# Access Compliance Report

## Public Rights-of-Way

Intersection ID: 46027	Main Street: BOYSENBERRY_CT	Cross Street: PAULINE_LN	Location: NE
ADA ID: A7070C6F0E9C	Ramp Type: PerpDiag	Initial Pass/Fail: Fail	Overall Compliance: No
		Severity Score: 8.75

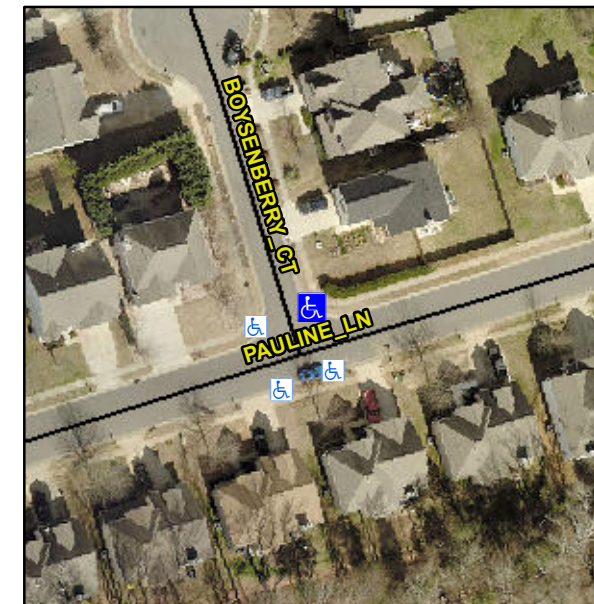
**Not Found, R304.5.1**

Compliance	Description	Data	Compliance	Description	Data
N/A	Ramp Length (in)	46.5	Yes	Ramp Slope (%)	6.0
No	Ramp Width (in)	38.0	Yes	Ramp XSlope (%)	1.8
N/A	Flare Type LT	N/A	N/A	Flare Type RT	N/A
N/A	Flare Slope LT (%)	N/A	N/A	Flare Slope RT (%)	N/A
N/A	Flare Traversable LT?	N/A	N/A	Flare Traversable RT?	N/A
N/A	Landing Length (in)	N/A	N/A	DWS Provided?	N/A
N/A	Landing Width (in)	N/A	N/A	DWS Contrast?	N/A
N/A	Landing Slope (%)	N/A	N/A	DWS Length (in)	N/A
N/A	Landing X Slope (%)	N/A	N/A	DWS Full Width?	N/A
N/A	Landing Curb? (Y/N)	N/A	N/A	DWS Offset (in)	N/A
N/A	Shared Landing?	N/A			
N/A	Gutter Ponding?	N/A	N/A	Gutter Slope (%)	N/A
N/A	Gutter Lip Ht (in)	N/A	N/A	Gutter X Slope (%)	N/A
N/A	Painted X Walk1?	No	N/A	Painted X Walk2?	No
	X Walk 1 Direction	To W		X Walk 2 Direction	To S
N/A	X Walk 1 Width (in)	N/A	N/A	X Walk 2 Width (in)	N/A
	X Walk 1 Slope (%)	6.8		X Walk 2 Slope (%)	2.2
	X Walk 1 X Slope (%)	2.1		X Walk 2 X Slope (%)	5.5

**Remove & Replace Curb Ramp With Two New Directional Ramps or Equivalent.**
